Product Change Notification

Please kindly be informed that the original LED Driver G5968C is EOL. Ampire will change LED driver from G5968C to TPS61185.

The PCB version change from 800480B-A0H REV.A to 800480B-A0H REV.B

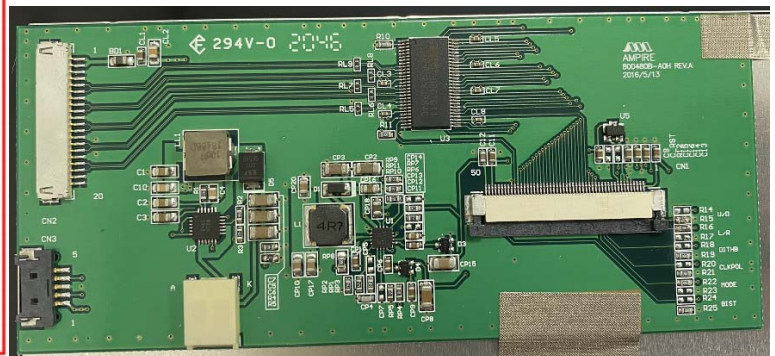
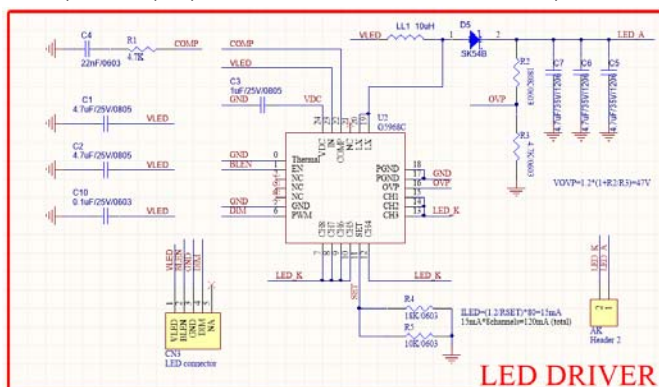
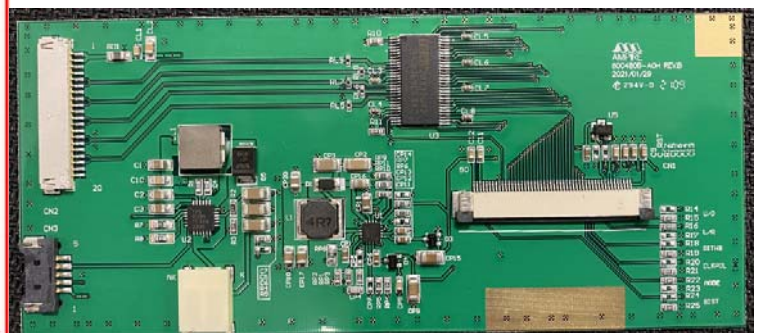
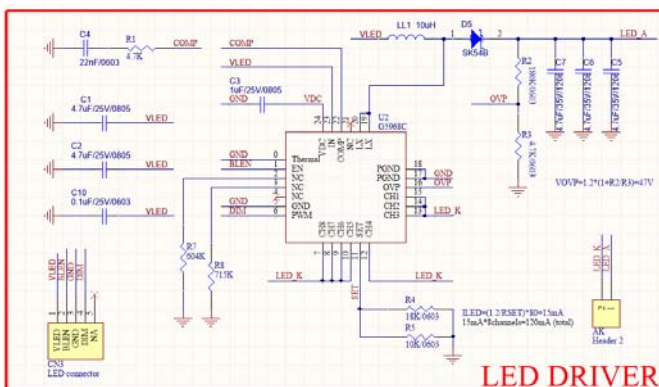
There is no any change on the LCD dimension, and interface.

They are compatible of the electronic,mechanical ,Optical and reliability feature.

Current(G5968C) (PCB Version: 800480B-A0H REV.A)

New(TPS61185) (PCB Version: 800480B-A0H REV.B)
